SUBJECT: NRC STAFF ASSESSMENT OF DUKE ENERGY CAROLINAS,  
LLC., OCONEE EXTERNAL FLOODING ISSUE (TAC NOS.  
ME4441, ME4442, AND ME4443)

## **NRC Assessment of Oconee External Flooding Issue**

**Satellite image of Jocassee Dam showing submerged quarry site and embayment area below the dam which has a restricted outlet connection to the rest of Keowee Lake**

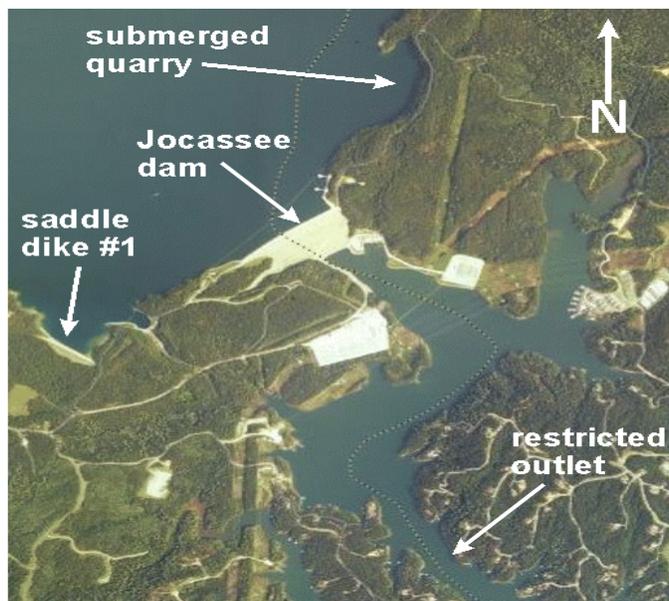
The tailwater effect of the convoluted flood pathway below Jocassee Dam was not considered. A limit on the depth of hypothetical breach cutting at Jocassee (and therefore on the peak discharge) is provided by the tailwater elevation of 800 ft, which represents the Keowee normal pool level. This is the base elevation that is assumed for the hypothetical breach at Jocassee. It is conservative to not include the tailwater effect of the convoluted flow pathway below Jocassee Dam because this would shorten the time required to empty the reservoir.

Figure 2: TWO-DIMENSIONAL MODEL BOUNDARY DEFINITIONS (Duke, 2010)

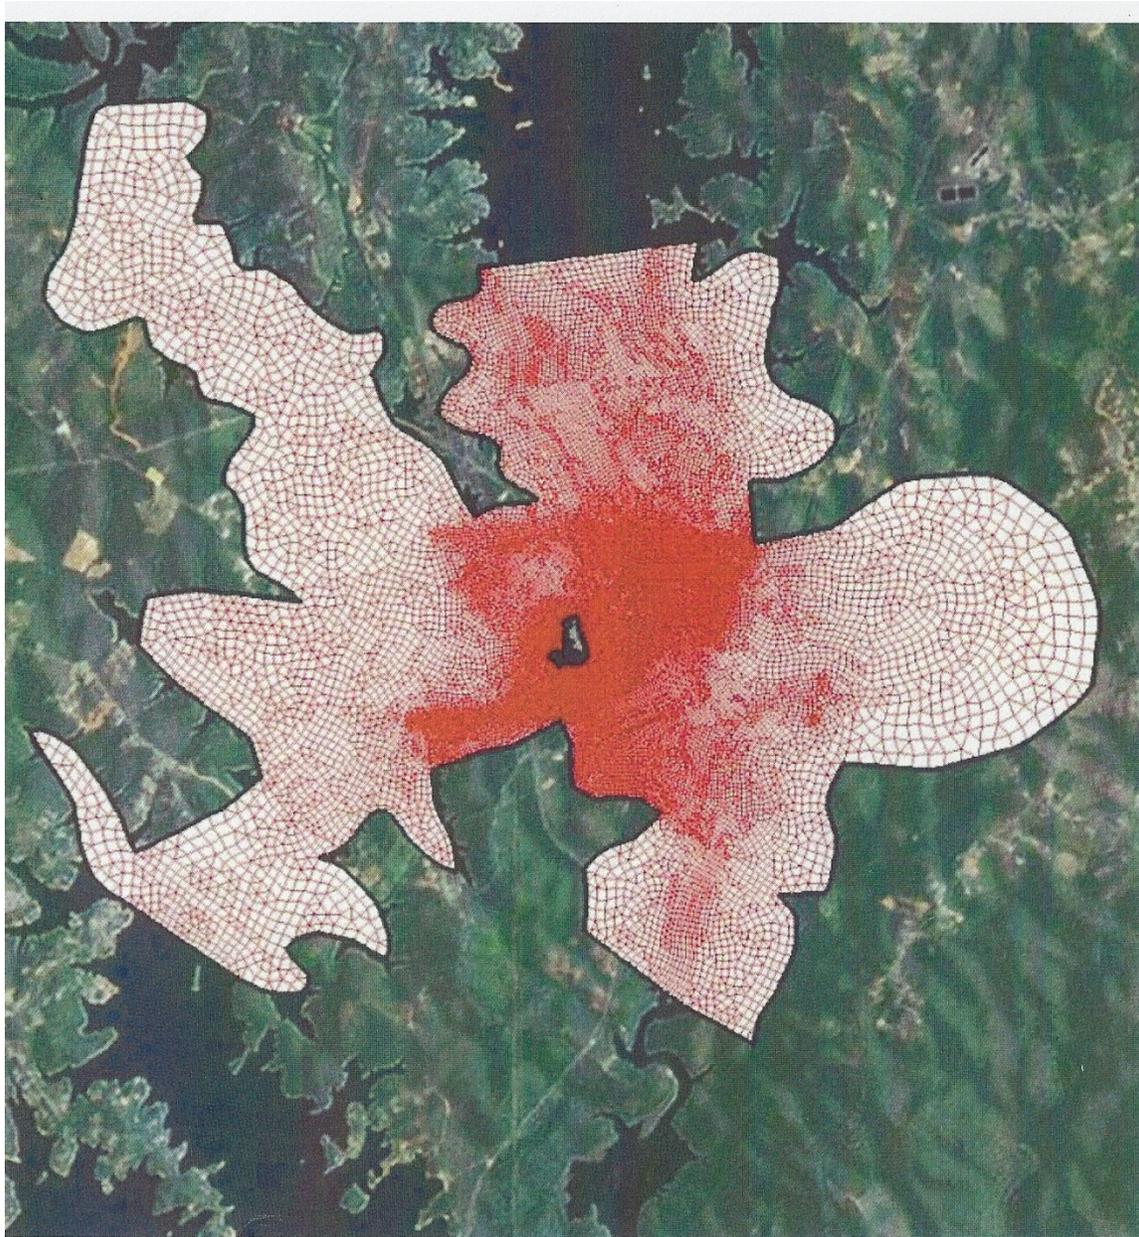
The one dimensional HEC-RAS and two-dimensional SRH-2D models are not dynamically Coupled; and mass and momentum between the two models cannot be conserved. Hence, the potential backflow between the inflow and outflow boundaries cannot be incorporated into the

model. Also, the simulations represent an extreme and unobserved scenario and parameters, such as, roughness coefficients over the site cannot be calibrated, requiring the selection of conservative values. The lack of coupling resulted in higher water levels from the 2-D simulations at the upstream boundaries than from the HEC-RAS runs (Wilson, 2010 and Young, 2009). The peak of the higher values at the upstream boundary after a short dip, as plotted by

Wilson, appeared about 20 minutes later than the peak at Keowee. This indicated a possible reflection of the flood wave at Keowee Dam intensified by the rigid (no backflow) upstream boundary condition. This intensified reflection may have resulted in greater flow through the Keowee tailrace. The ONS peak appeared occur earlier and was probably unaffected, although it was still about a foot higher than the HEC-RAS simulation.
